Meeting Date: July 27, 2020

PLAN COMMISSION REPORT

Description: Review a request to approve a site plan for a 51,756 square-foot addition to the existing building located at 12725 4 Mile Road.

RE: Central Storage Warehouse Addition – Site Grading Plan Review

SHEET TITLE:
GRADING & DRAINAGE PLAN

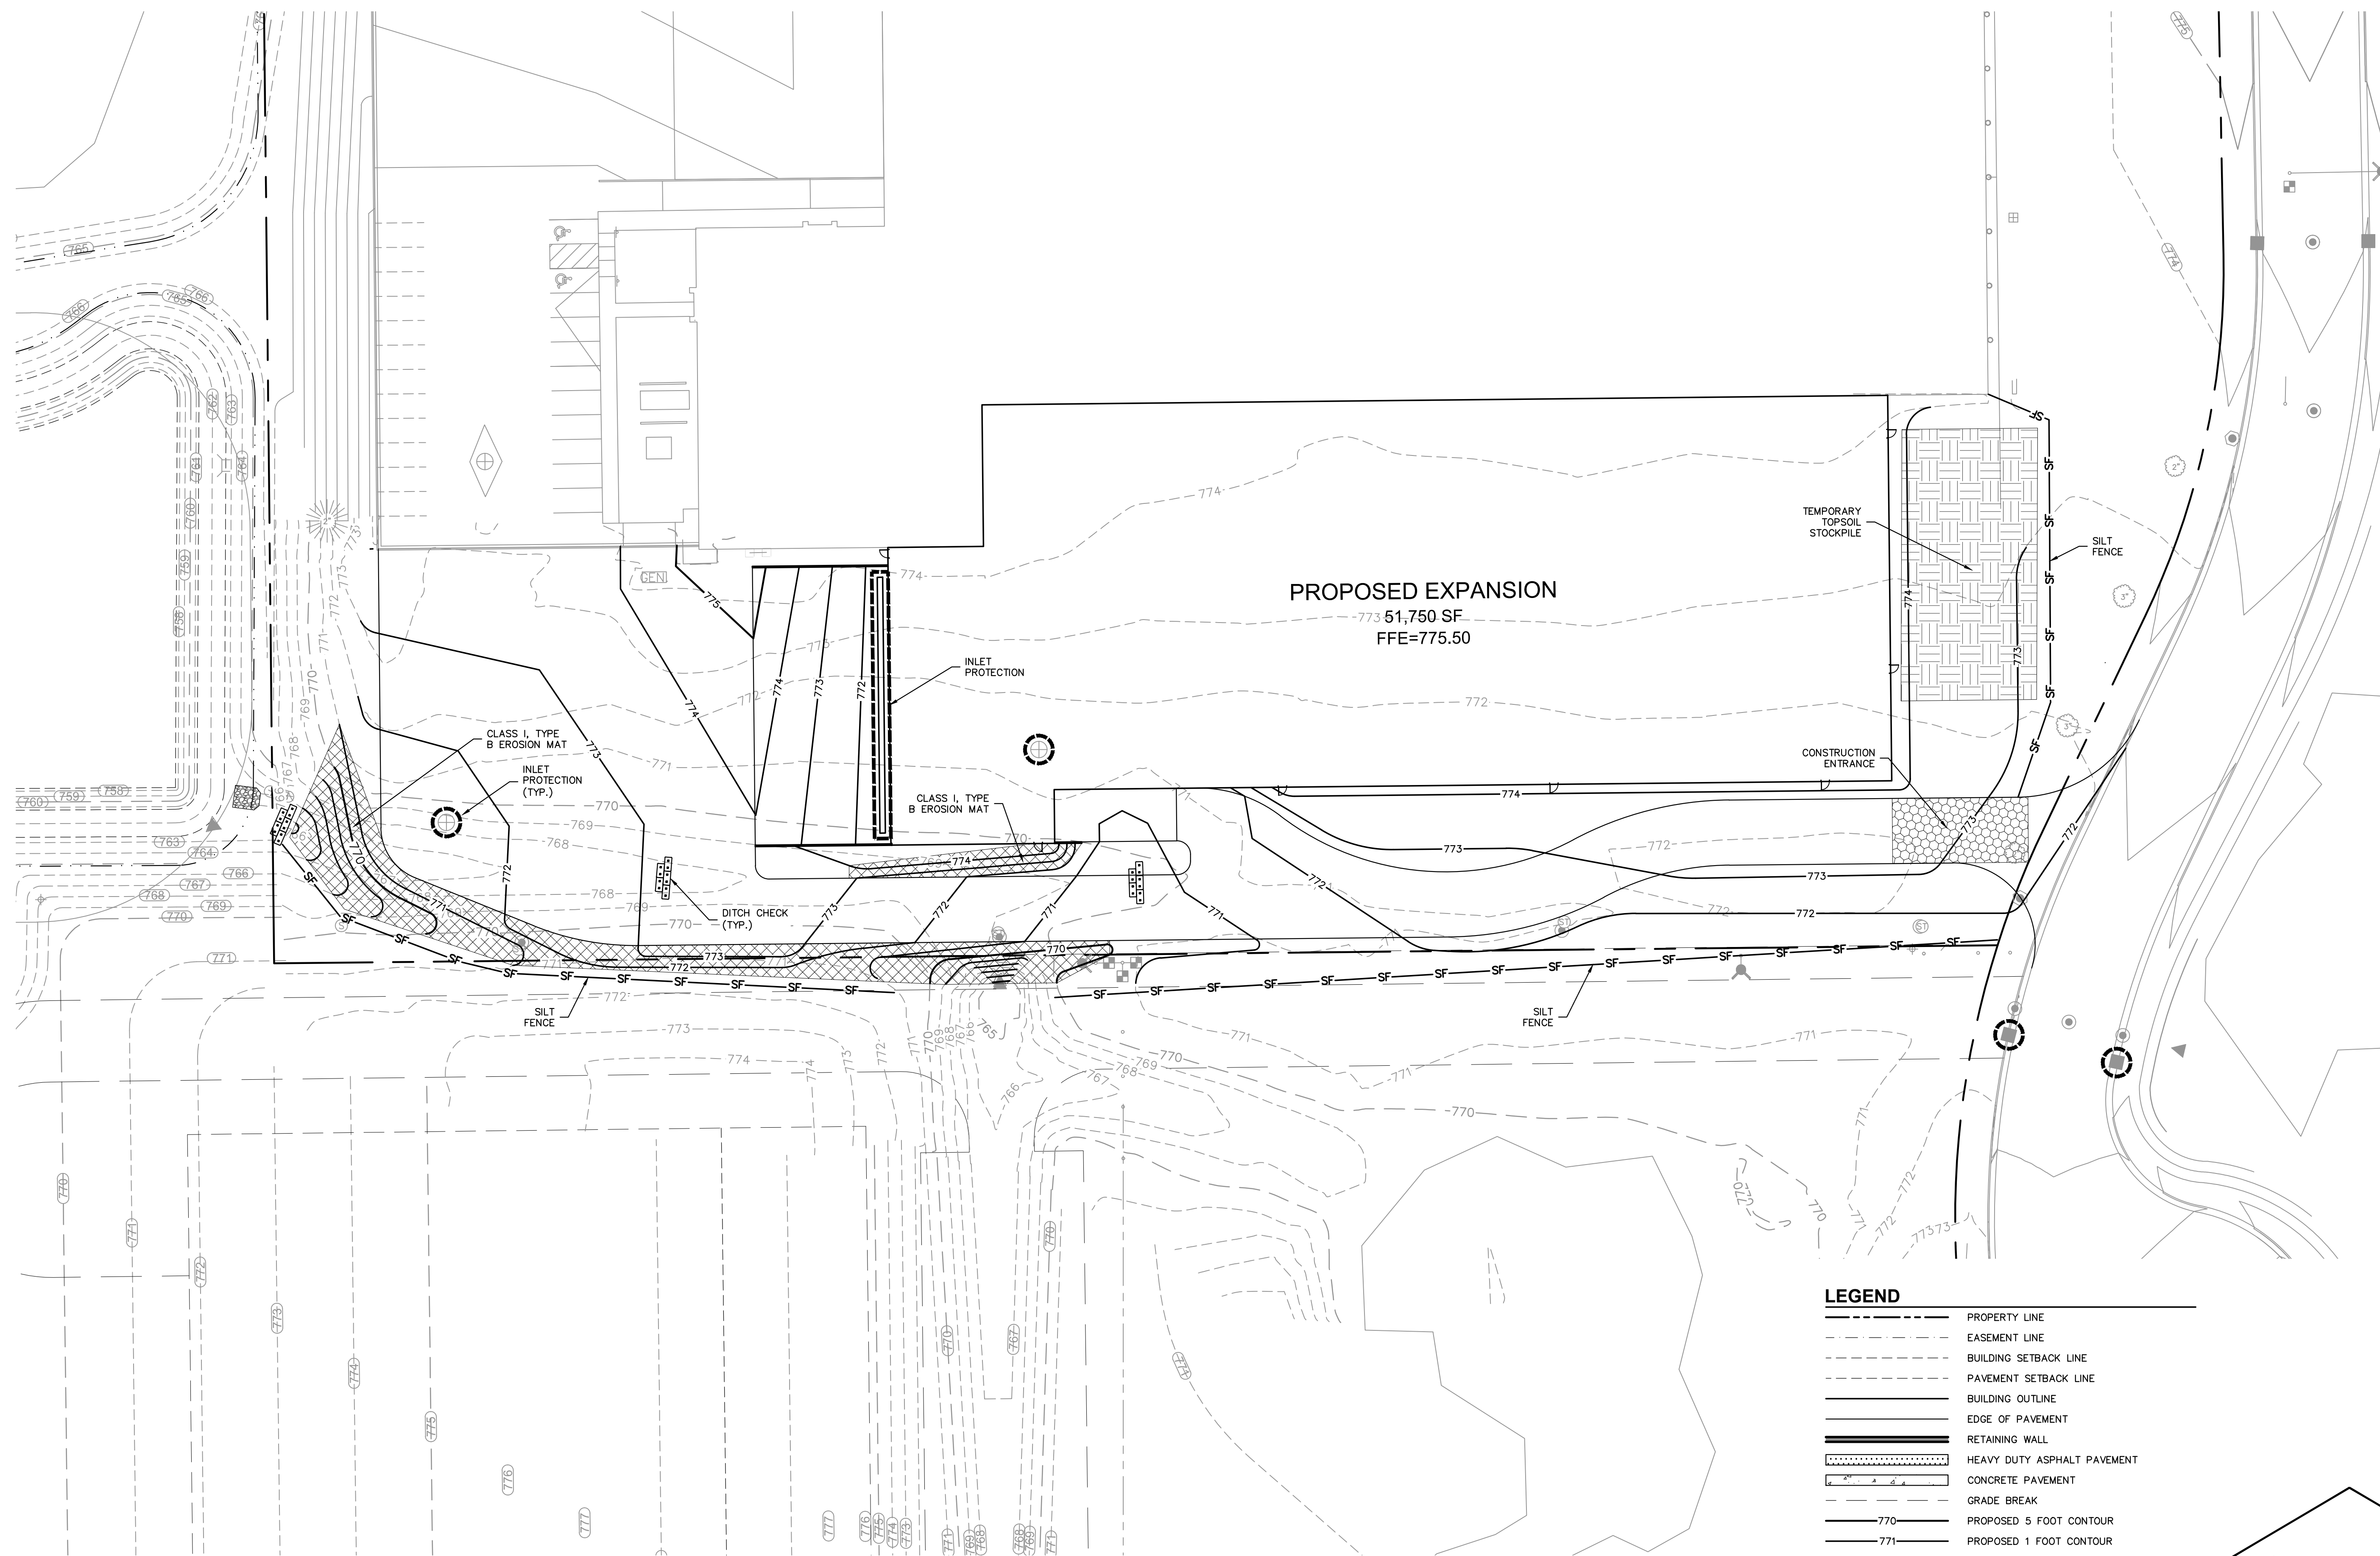
- Provide proposed spot grades along the lot line and at the match points on the abutting property opposite the proposed grades on the driveway (+- every 60’).

- Due to the driveway encroaching on the storm sewer easement and the existing grades on the property, grading will need to be performed on the abutting property to the South. Will need to provide written permission from the abutting property owner that grading can be performed on the abutting property.

- Will need to provide the existing manhole rim elevations and if the manholes will need to be adjusted to match the proposed grading plan.
- Due to the steep side slopes off the proposed driveway near the existing storm sewer, the storm sewer will be required to be extended 1 pipe length to lessen the slopes.

- Will need to provide a railing on top of the retaining walls in the details.
- On the East side of the additional truck bay, there is a grade of 770.83, which drains the loading dock to the South across the drive to the storm sewer. In the event that the storm sewer becomes plugged, there shall be an overland flow path that is lower than this elevation. It is suggested that the 771.90 swale grade to the West of the storm sewer be lowered to a minimum of 770.25 to provide this overland flow path to protect the loading dock area.
